Appl. No. 10/506,996  
Amdt. Dated Jan. 31, 2006  
Reply to Office Action of Nov. 17, 2005

**Amendments to the Drawings:**

**FIG.4**

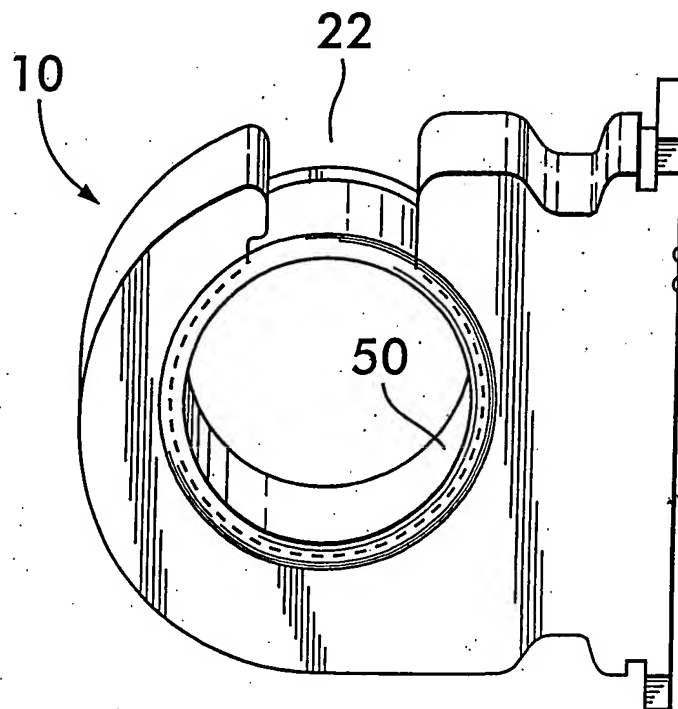
The attached sheet of drawing includes changes to Fig. 4. This sheet, which includes Figs. 4-5, replaces the original sheet including Figs. 4-5. In Fig. 4, element 40 has been re-numbered as element 41.

The Applicants have amended their drawings so that numeral (40) shown in Figure 4 has been changed to (41). Accordingly, the specification has also been amended so that now “wire bundle” is used to designate (40) and “insert” is used to designate (41). The Abstract has been corrected to remove the term “means.” The Applicants have amended their claims to more clearly define what is considered the invention. The indefinite phrase “attachment means” has been removed from the claims and reference of dependent claims to either the “fastener” or the “insert” which lacked antecedent basis have been deleted. Claim 7 has been amended to define the flap as being inwardly pivotable and located within the hook between the jaws. The Applicants have noted the re-numbering of claims due to the previous cancellation of claim 5. Support for these amendments is found in various places throughout Applicants’ specification. No new matter has been added.
